HISTORIC LANDMARK COMMISSION
STAFF REPORT

Rees Single-family Dwelling
New Construction Petition PLNHLC2008-00199
34 West Rear Zane Avenue
Capitol Hill Historic District
September 3, 2008

Exhibit A: SITE PLAN

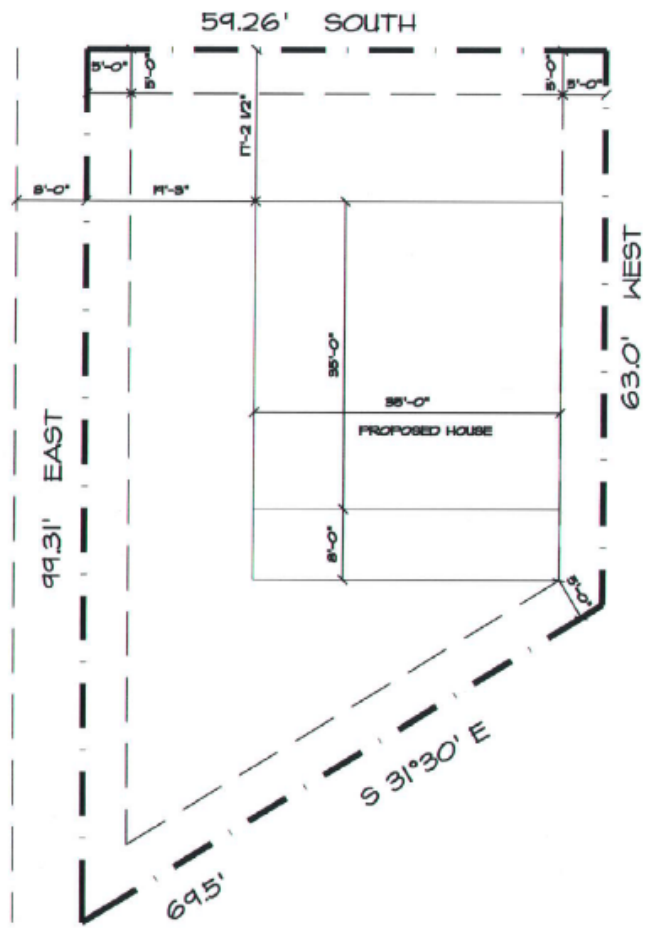
Finding: Because of the slope of the lot and neighborhood, most of the homes were built with a limited front yard setback. The applicant has proposed a building that is oriented with the front porch facing the street, and has a front setback measured as the average of all of the buildings on the block face. The driveway enters from Zane Avenue and courses to the proposed garage on the side of the home. This configuration is consistent with the development pattern in the immediate area.

FRONT ELEVATION
SCALE 1/4"

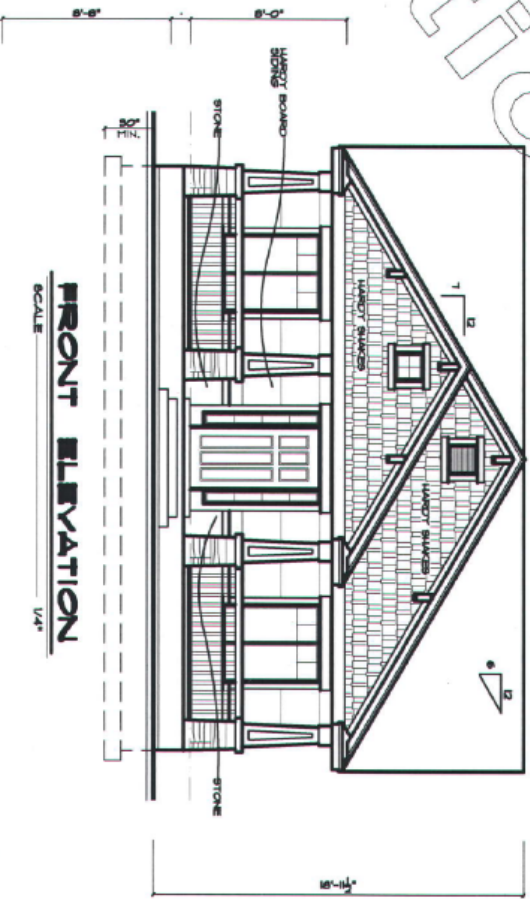
The building lot is steeply sloped traversing downward from the street toward the rear lot line as a result, the height of the building increases as it runs toward the rear of the lot. The proposed east elevation will be 19 feet tall with the south and north elevations increasing in height, as they descend the slope, to a maximum height of 25 feet. Likewise, the yards of the buildings on the block face have natural slopes and their height is higher on sides of the building that do not face the street (no height numbers are available). Therefore, staff finds that in spite of the increased height, the visual impact of the home when viewed from the street is consistent with the surrounding structures and streetscape.

Staff recommends that the Historic Landmark Commission consider granting the exception for the additional 2 feet of height, based on the findings that the primary façade of the structure is compatible with the surrounding streetscape; and that additional height is warranted due to the steep slope of the lot.

The visual impact of the mass and scale of the building as it relates to the surrounding architecture is significantly aided by the large dormer over the front porch. This element acts to soften the impact of the primary ridgeline running parallel to the street, and provides architectural interest to the building. The pitch of the roof is greater than that of the contemporary homes, and less than that of the historic home, and is within the range of construction on the street. The width, mass, and scale of the home are within the parameters of the surrounding vernacular and streetscape, as the structure is no wider or narrower than the majority of homes in the area.

1. Approval of the final details of the design shall be delegated to Planning Staff based upon direction given during the hearing from the Historic Landmark Commission.
2. The hardie plank siding shall have a smooth finish. No faux wood grain imprints shall be permitted.
3. The primary ridge of the structure shall not exceed 25 feet above established grade in height.
4. The project must meet all other applicable Zoning Ordinance requirements, including setbacks, maximum footprint and lot coverage. Any request for an exception to these rules shall require additional review and approvals as dictated by the Zoning Ordinance.
